KAHLE LAKE DAM

NDI No. PA 00825
PennDER No. 61-20

PHASE I INSPECTION REPORT
NATIONAL DAM INSPECTION PROGRAM

AUGUST 1979

PHOTO 3. Outlet of Principal Spillway (Outlet Discharge Basin)

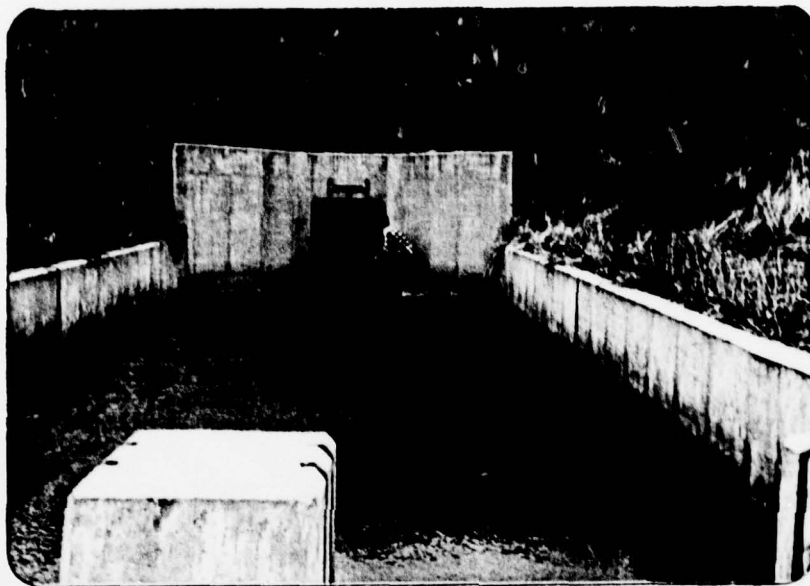
- c. Appurtenant Structures - A few minor cracks were noted along the walls of the outlet discharge basin of the principal spillway. Also, a small ditch was noted to the right of the outlet channel undercutting the riprap.

- 1) Regrade, treat, and seed the erosion channel on the downstream slope.
- 2) Institute a program to monitor the quantity and turbidity of the water within the marshy area.
- 3) Repair the cracks in the walls of the outlet discharge basin and the concrete chute below the auxiliary spillway.
- 4) Regrade the area on the right side of the outlet channel where the riprap has been undercut.
- 5) Regrade the low areas along the crest of the dam.
- 6) Clear the weep holes in the stilling basin.
- 7) Replace the joint filler where missing along the base of the overflow weir in the spillway.

PHOTO 7. Concrete Weir Section of Auxiliary Spillway

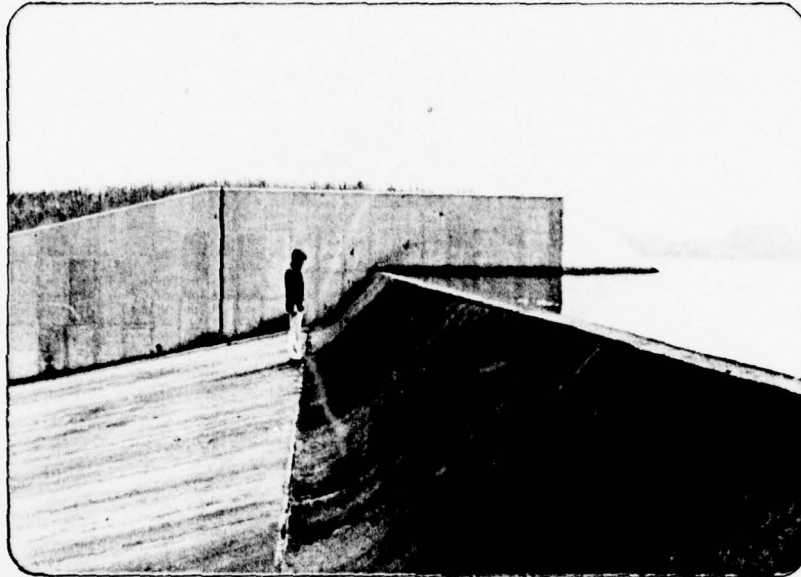
VISUAL EXAMINATION OF		OBSERVATIONS	REMARKS OR RECOMMENDATIONS
CONCRETE WEIR	1.	Concrete was in good overall condition. The joint sealer is missing at the base of the ogee section.	1. Recommend replacing the joint sealer.
	2.	Some minor cracking was noted along the walls of the concrete chute.	2. The cracking should be repaired, as necessary.

- 5) Regrade the low areas along the crest of the dam.
- 6) Clear the weep holes in the stilling basin.
- 7) Replace the joint filler where missing along the base of the overflow weir in the spillway.

PHOTO 8. View of Stilling Basin and Concrete Chute Looking Downstream

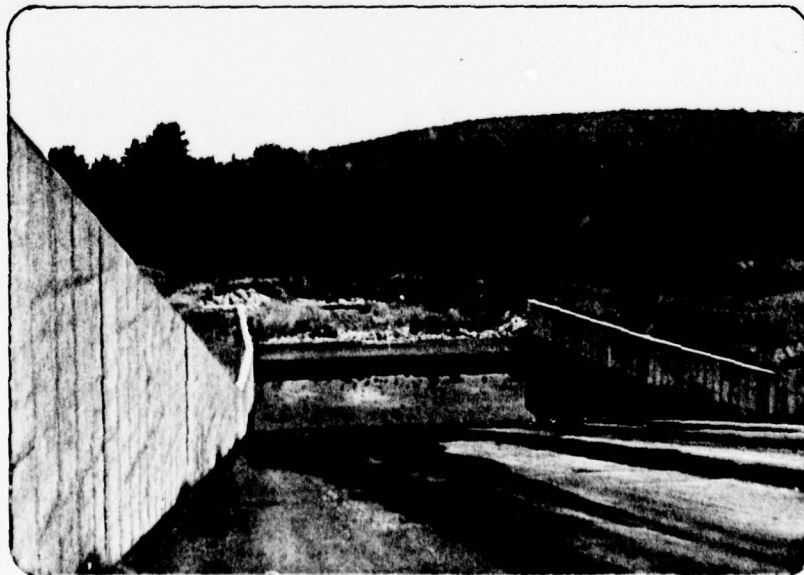
| <p>2. Several weep holes in the stilling basin were plugged.</p> | <p>2. The weep holes should be unplugged.</p> |
